RESPONSE TO COMMENTS

Planning Application No. A/NE-TKP/3

Project: Proposed Village Housing
Location: D.D. 293 Lot Nos. 662 S.A, 664 S.B, 668 S.B, 669 RP & 664 S.A, 667 S.C, 668 S.A, 669 S.B, 671 S.B & 654 S.A RP, 658 RP, 659, 660 RP, 661 RP & 658 S.B, 658 S.C, 660 S.B, 660 S.C, 661 S.B, 662 S.B, 662 S.C, To Kwa Peng, Sai Kung North, New Territories

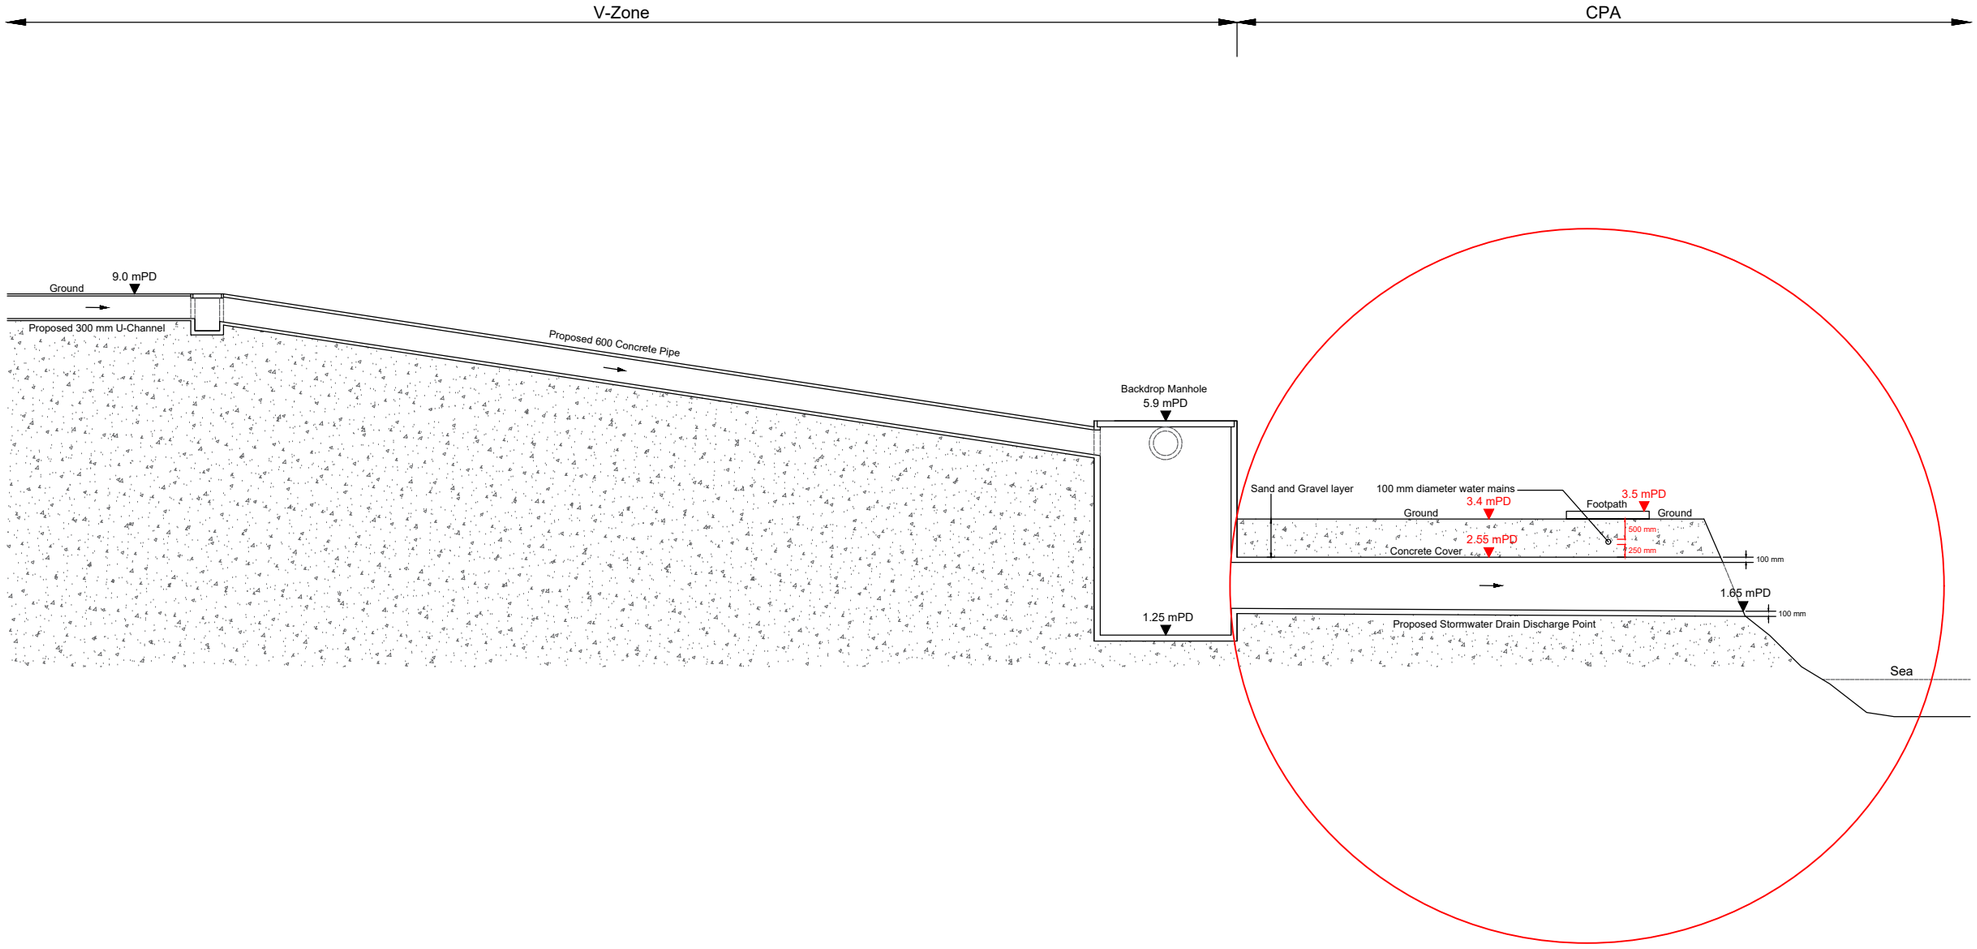
ITEM	DESCRIPTION	RESPONSE
a & b	in view that majority of the proposed work is on the CPA zone which is well-vegetated and Pak Tam Road and a large part of the footpath connected to the Site are located within Sai Kung East Country Park (SKECP), the applicant should provide more information on the potential impact to local vegetation and on the means of transportation of the construction material to the Site for our future consideration; and as a reminder, the footpath concerned is narrow and the use of the footpath for transportation of construction materials / machineries is not advised. In view that the Site is assessable by marine access off a small pier nearer to the site, the applicant may explore the use of alternative routes in between the pier and the Site. Should there be a need to transport construction materials / machinery via SKECP, prior permission from relevant authorities including the Country and Marine Parks Authority, the Water Supplies Department and the Transport Department are required. Justifications for the use of Pak Tam Road and the footpath, if necessary, in SKECP as well as the type and photos of the vehicles/construction equipment involved shall be provided for consideration.	Due to the excessively long distance required to reach the construction site by traveling from Pak Tam Road through the pedestrian walkway, and because that section of road is extremely narrow, transporting materials is highly inefficient and not favorable for our operations. Therefore, we ensure that no building materials, machinery, or vehicles will use the pedestrian walkway along Pak Tam Road to reach the construction site. We will fully adopt marine access; all materials and equipment will be delivered by marine vessels to the existing small pier located near the Site. Materials unloaded at the pier will be directly and efficiently transferred over this short distance into the Site using manual labor or lightweight, low-impact tools (e.g., electric hand-trolleys). To further safeguard the well-vegetated CPA zone, temporary protective hoarding/fencing will be erected along the Site boundary prior to the commencement of any works. No stockpiling of materials will be allowed outside the Site or along the short path from the pier.
